**Report of the Production Readiness
Review of the HL-LHC AUP MQXF Cable
Fabrication Task 302.2.03**

US-HiLumi-doc-2080

US HL-LHC Accelerator Upgrade Project

January 22nd 2019

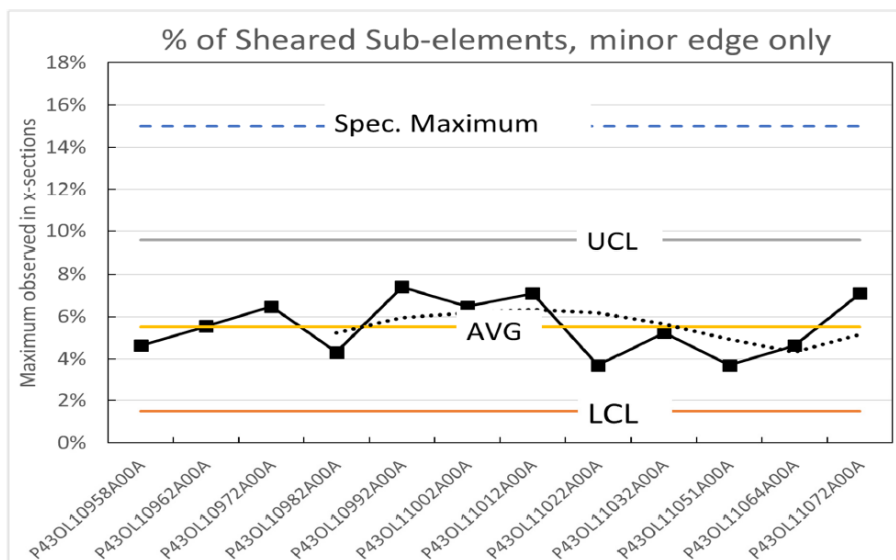
Fig 1. Using data provided we show the trend of the maximum % of sheared sub-elements observed at the minor edge for the first 12 production unit lengths. Note that the average is well below specification and the dotted line is the running average of 4 unit length of cable. A sudden increase above the upper control limit (UCL) should be a cause for concern even if it is less than 15%.

Fig. 2 Using the I_c of extracted strands from data provided, the average I_c at 12 T and 15 T of the extracted strands heat treated with a coil are plotted vs. coil ID.

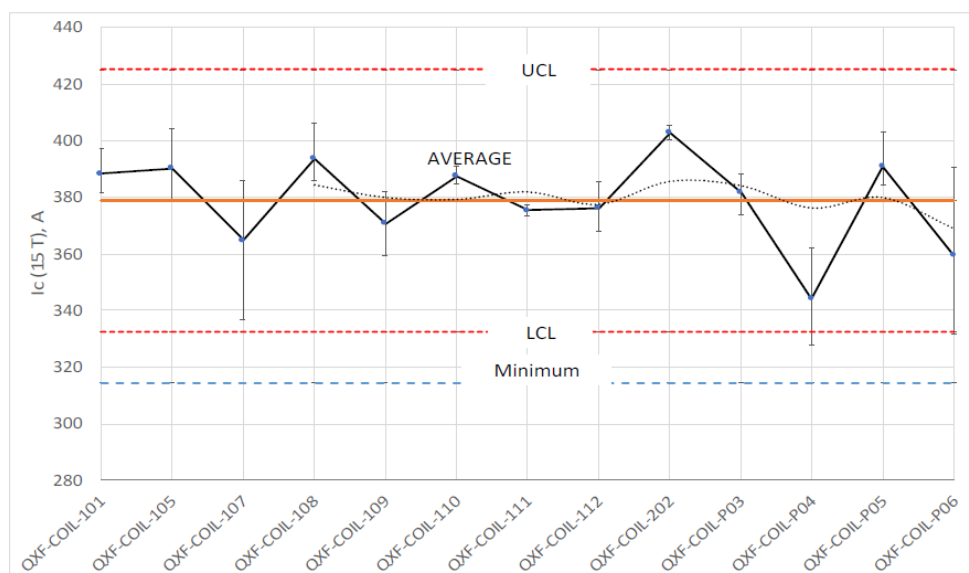
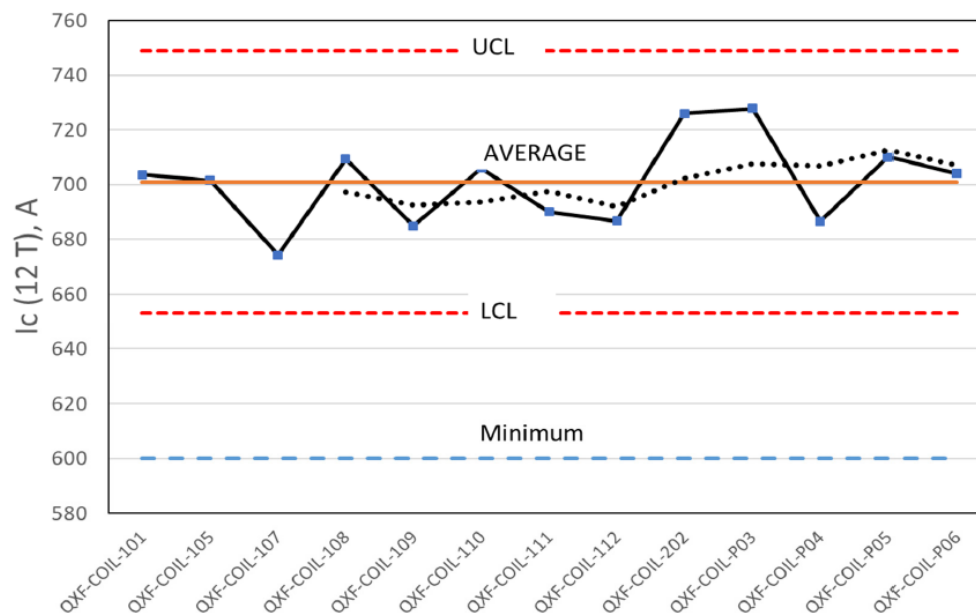
Experience does indicate that cable I_c is well above minimum specification. If the cable I_c trends towards the lower control limit (LCL) established by the first 12 cables, it should be a cause for pause and evaluation. The dotted line is the 4-coil running average.
